**Location**  
**Victoria Embankment Foreshore**  
 City of Westminster

**Document Information**  
**Application for Development Consent**  
 Proposed  
 Landscape plan sheet 2 of 2  
 Book of plans - section 18  
 DCO-PP-16X-VCTEF-180013 - Rev 2  
 Sept 2022

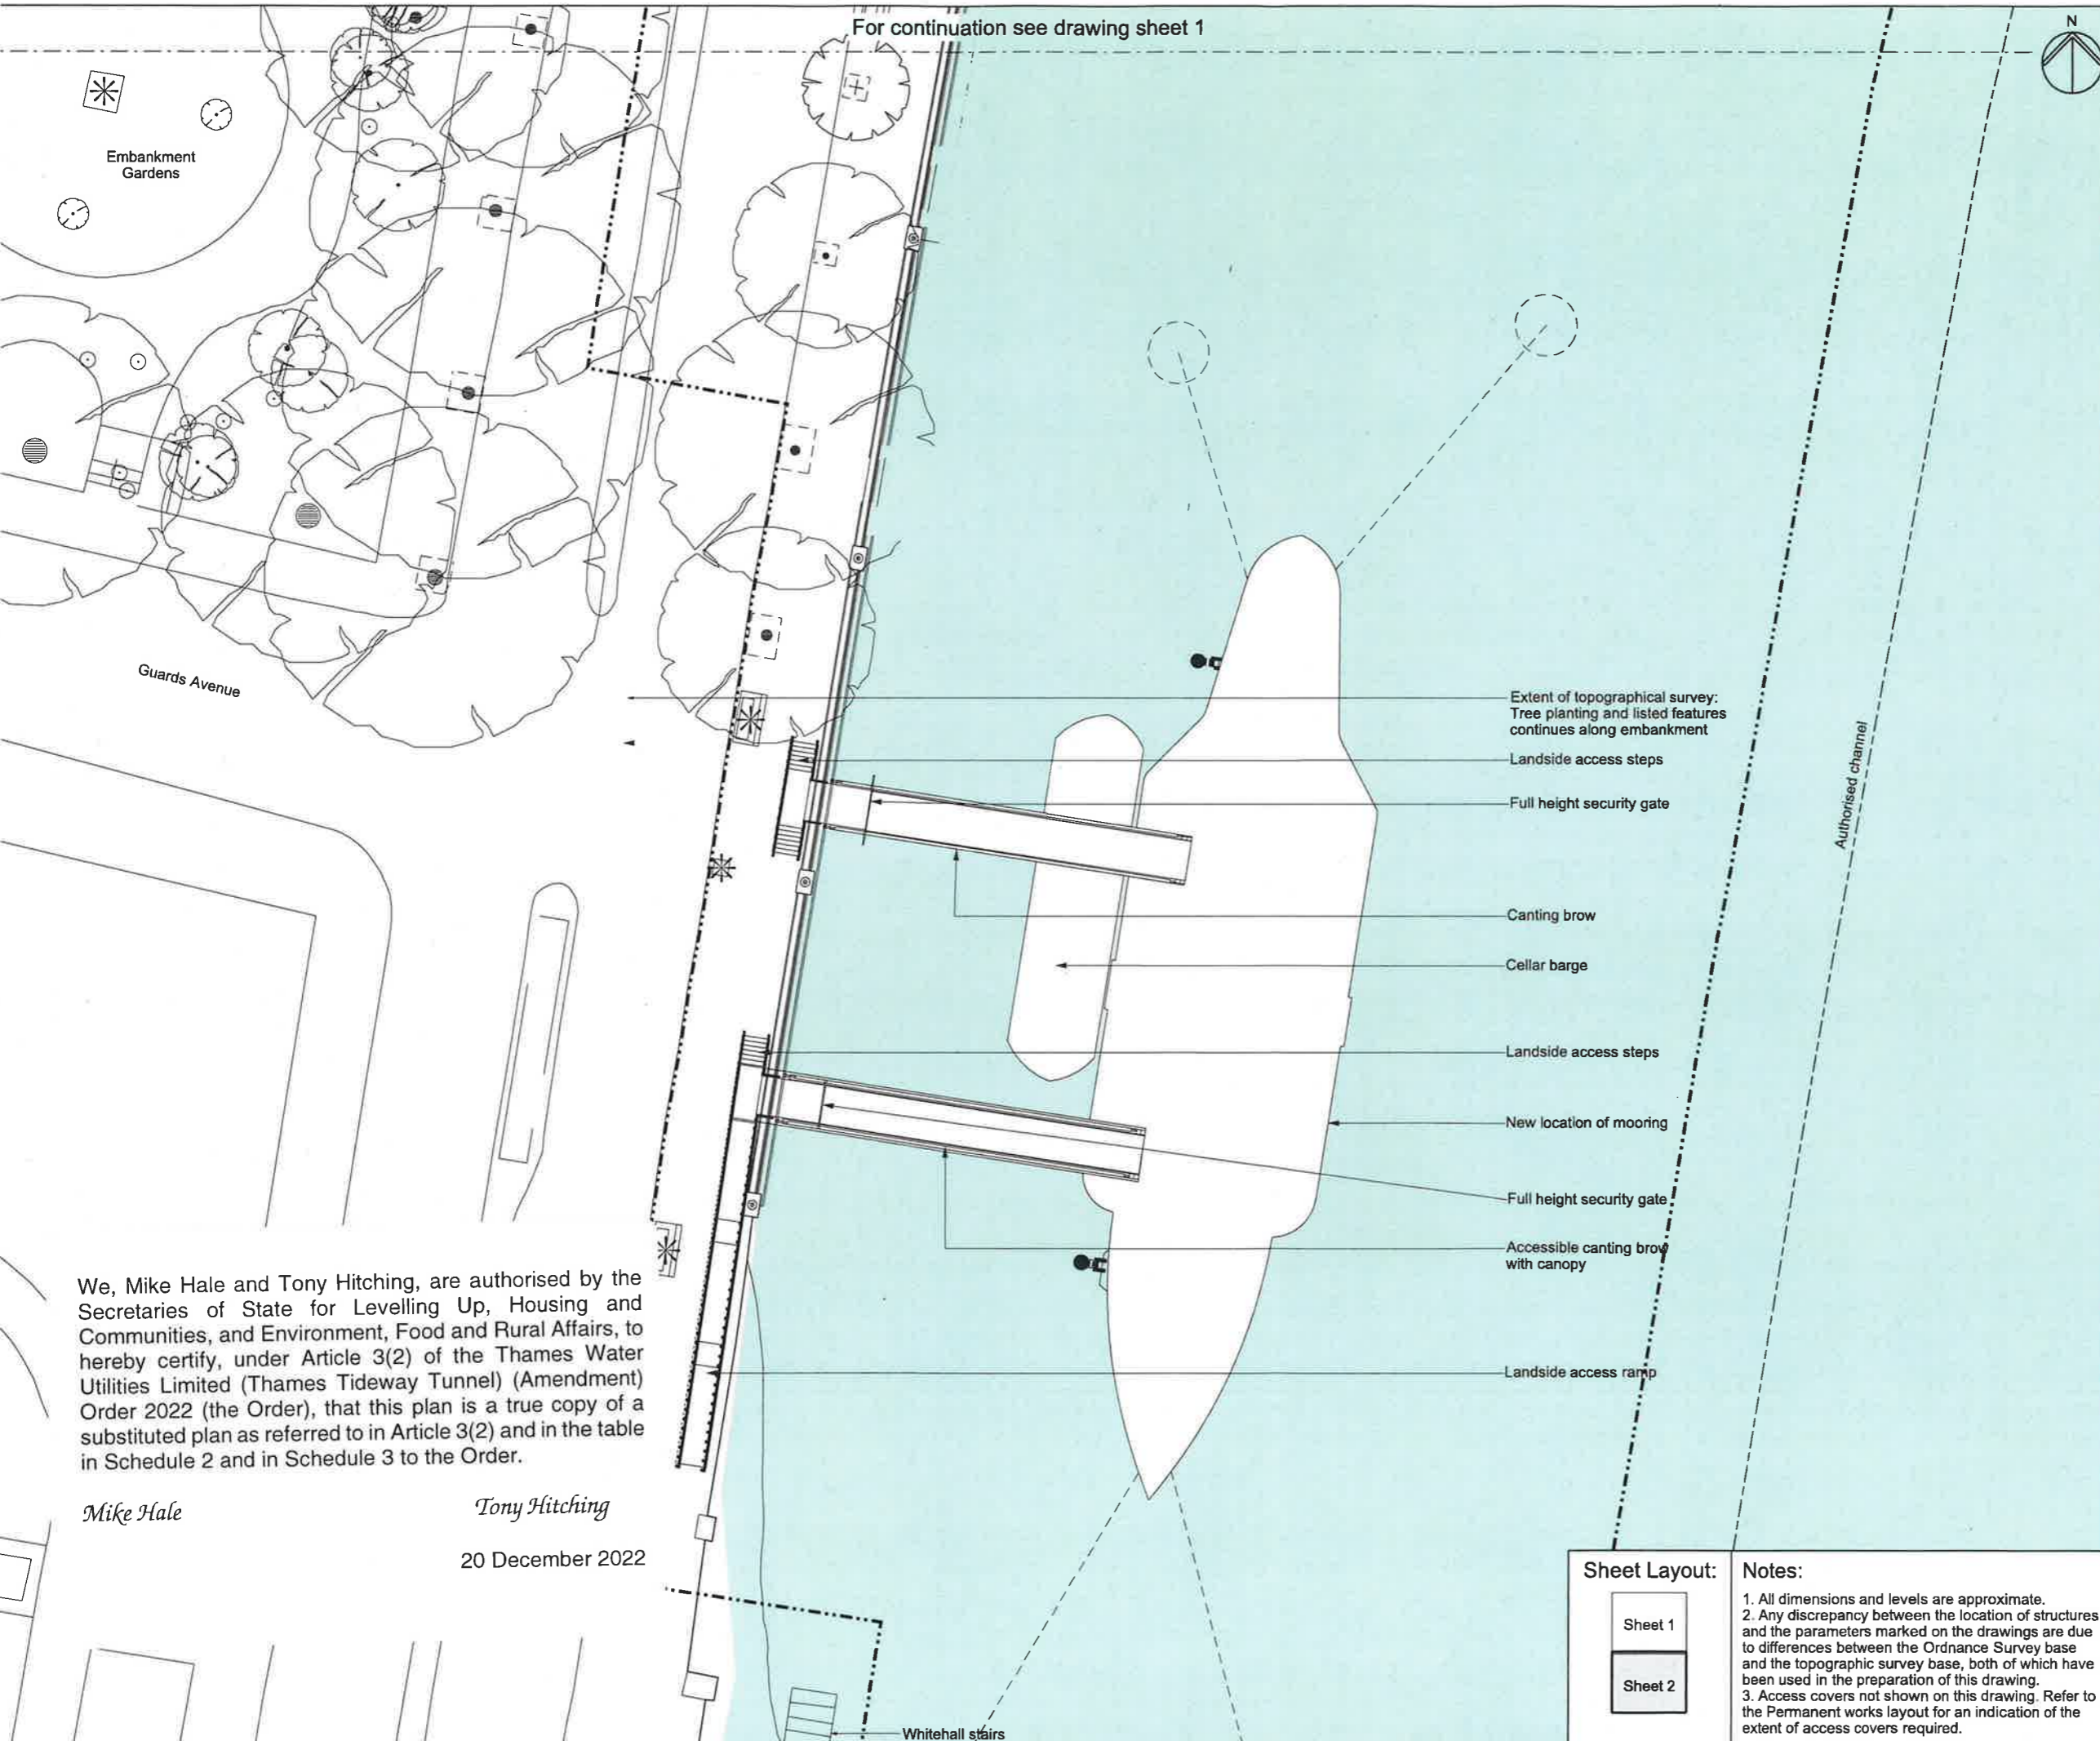
- Rev 1:**
1. Temporary and permanent vessel mooring access ramp revised. Anchors and chains shown. Service mooring reinstated on piles. LLAU extended.
- Rev 2:**
1. Service mooring removed.
  2. One purple parameter removed.
  3. New mooring location revised.
